Project	IEEE 802.16 Broadband Wireless Access Working Group < http://ieee802.org/16 >	
Title	Enhancements to UCP LBT	
Date Submitted	2007-09-11	
Source(s)	Paul Piggin NextWave Broadband Ken Stanwood NextWave Wireless Yair Bourlas NextWave Broadband Kathy Sohrabi NextWave Broadband	Voice: + 44 1249 800167 E-mail: ppiggin@nextwave.com Voice: +1 858 480 3327 E-mail: kstanwood@cygnuscom.com Voice: +1 858 480 3279 E-mail: ybourlas@nextwave.com Voice: +1 858 480 0549 E-mail: ksohrabi@nextwave.com
Re:	IEEE 80216-07/019 Task Group Review of P802.16h/D2c	
Abstract	Enhancement to UCP LBT based on simulation results and analysis	
Purpose	To address a handful of improvements to the LBT portion of the section 6.4 UCP.	
Notice	<i>This document does not represent the agreed views of the IEEE 802.16 Working Group or any of its subgroups. It represents only the views of the participants listed in the "Source(s)" field above. It is offered as a basis for discussion. It is not binding on the contributor(s), who reserve(s) the right to add, amend or withdraw material contained herein.</i>

Enhancements to UCP LBT

This document provides changes to IEEE P802.16h/D2b [1].

Figure h1—Basic LBT Opportunities

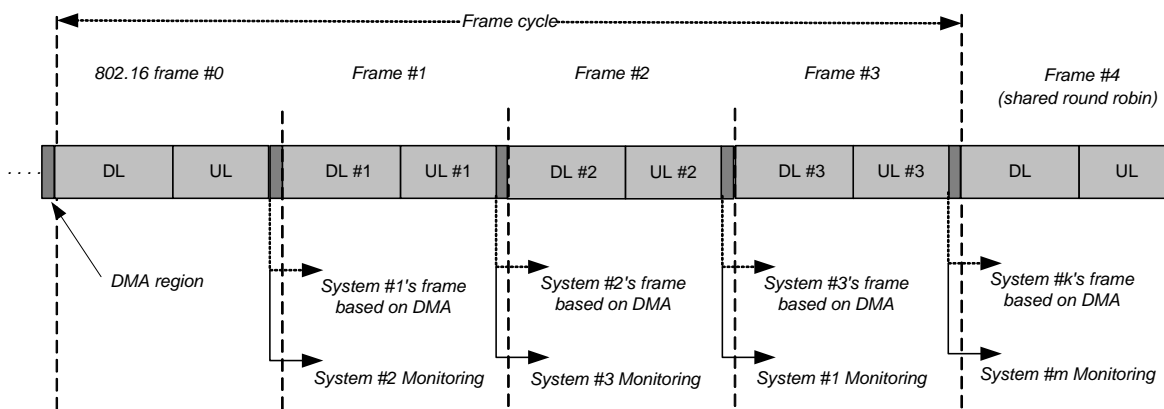
In ~~a similar way in~~ the gap between the UL and DL subframes, ~~as close to time to transmit the DL as possible,~~ the BS shall make measurements on the current state of the channel. The general case with three co-channel 802.16 systems is shown in *Figure h 1*.

[The gap between the end of the UL and the start of the DL in which Clear Medium Assessment \(CMA\) is performed must be of sufficient length to allow an asynchronous system to claim the channel if necessary. For instance if the](#)

asynchronous system is an 802.11 system, the gap must be at least the duration of the 802.11 AIFS in the band of interest.

Figure h2—LBT - UL MAP Relevance N

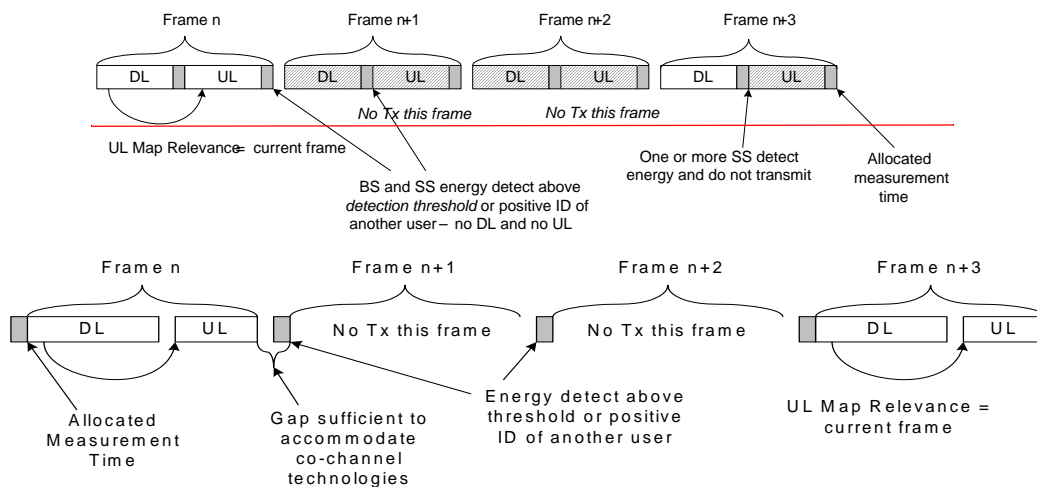
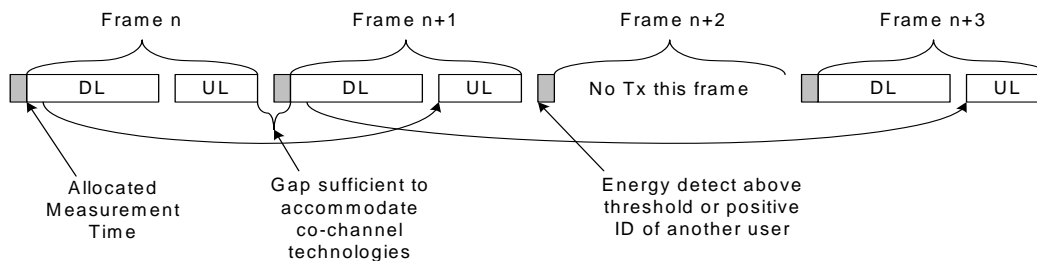
[Replace the following Figure.]

Figure h3—LBT - UL MAP Relevance N+1

Figure h4—Reclaiming the Medium

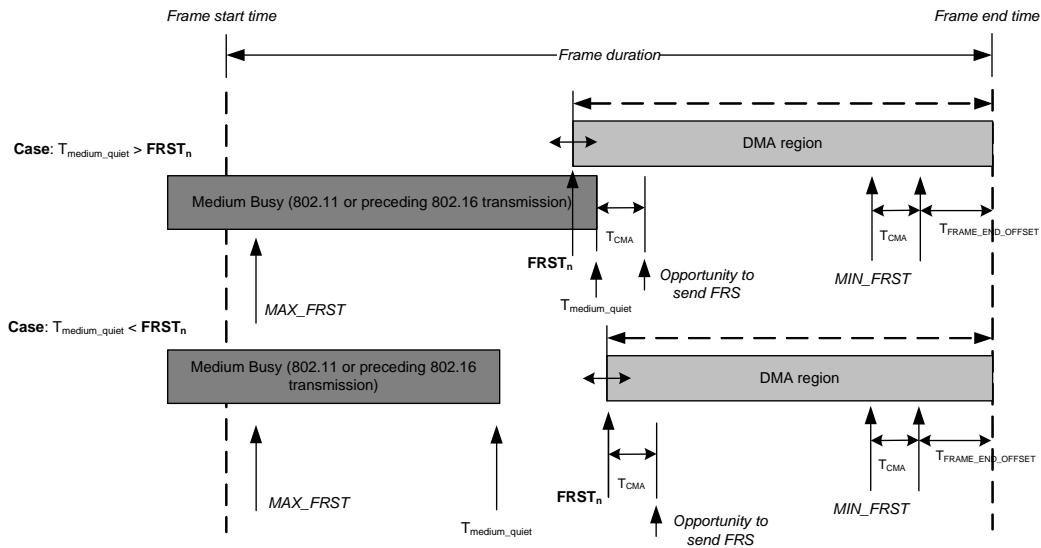
The parameters are applied as shown in Figure h 4.

$MIN_FRST = T_{CMA} + T_{FRAME_END_OFFSET}$
 $T_{FRAME_END_OFFSET} = 50\mu s$ (minimum time to Rx/Tx and send FRS)
 $T_{CCA} = 4/8/16\mu s$ (20MHz/10MHz/5MHz channels) – aligned with 802.11 values
 $MIN_FRST = 54/58/66\mu s$
 $MAX_FRST = 4000\mu s$
 802.16 parameters
 5ms 802.16 frame duration
 47 symbols per frame [DL=28, UL=19] symbol duration ~102μs
 TTG = 5μs

Figure h5—BS Dynamic Medium Access Protocol

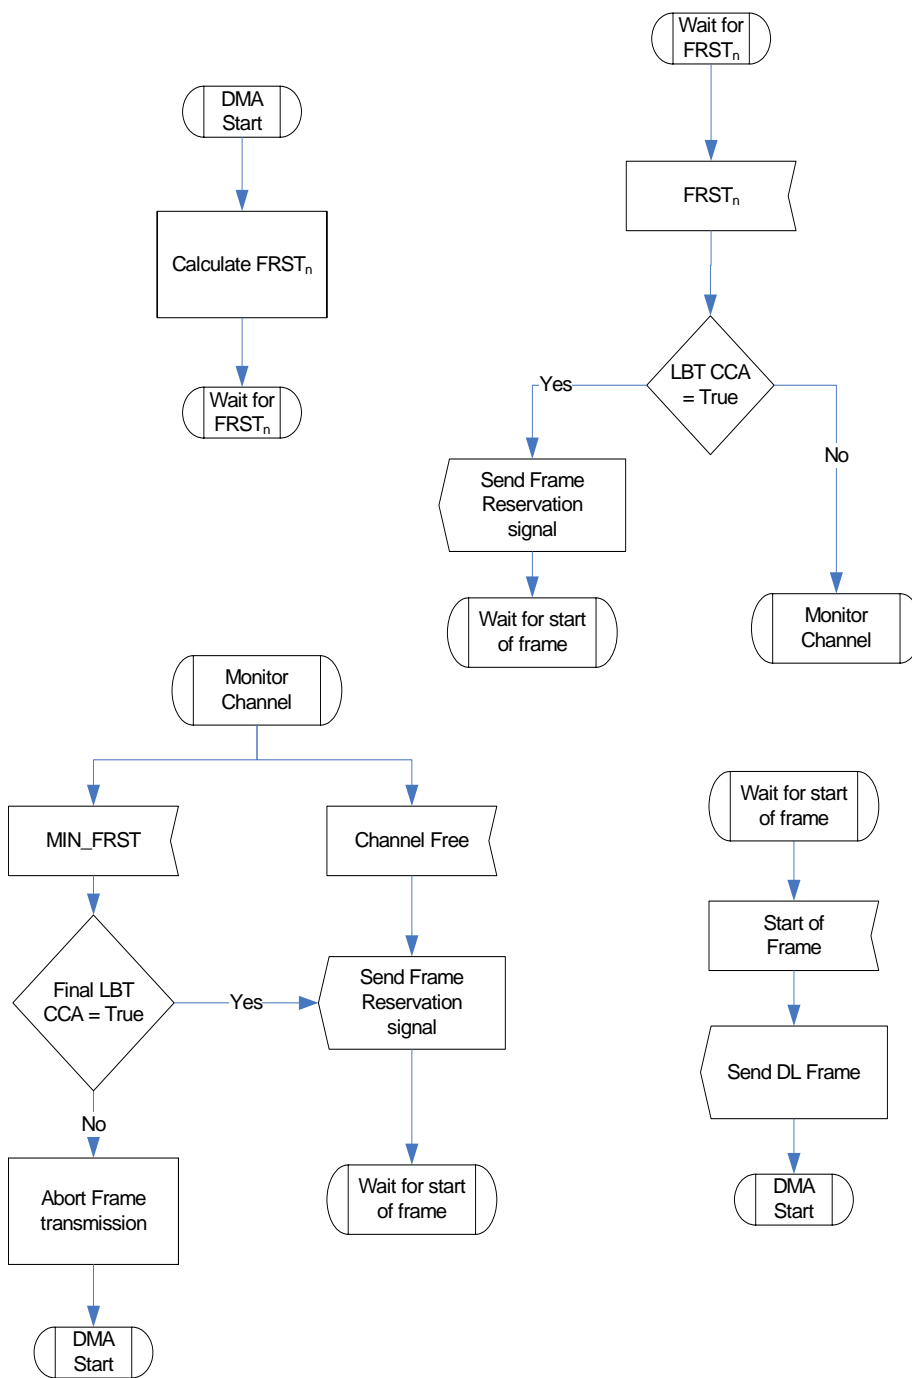
The BS SDL for the DMA protocol for reclaiming the medium is shown in Figure h 5.

Figure h6—UL FRS

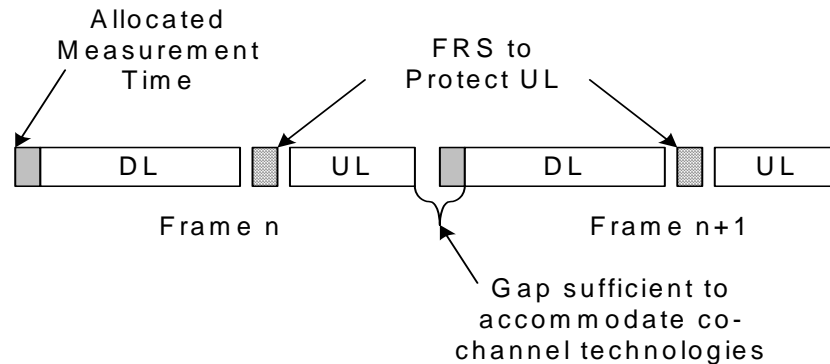
When using any carrier sense protocol, such as LBT, in a wireless environment the hidden node problem cannot be 100% avoided. It can only be mitigated. Additionally, in bands such as 3.65 GHz in the US, there is an aggravated hidden node problem due to the distinctly lower transmit power allowed for mobile devices compared to fixed, registered devices. The mobiles are more often geographically disadvantaged due to this transmit power disparity. Fixed, registered client devices can also be geographically disadvantaged (the classical hidden node problem), although not as often. To remedy this the BS transmits a Frame Reservation Signal (FRS) at the end of the DL subframe to reserve

the subsequent UL subframe (or used portion, thereof) for the subscriber stations. The form of the FRS is band dependent and should be structured to be receivable by other technologies that may be co-channel. For instance, in bands where 802.11 would be a typical co-channel asynchronous system, the 802.11 CTS transmitted using the appropriate 802.11 burst structure would suffice. The reservation of the UL subframe by the BTS precludes the need for the SS to also perform LBT. The use of the FRS to protect the UL is shown in Figure h 6.
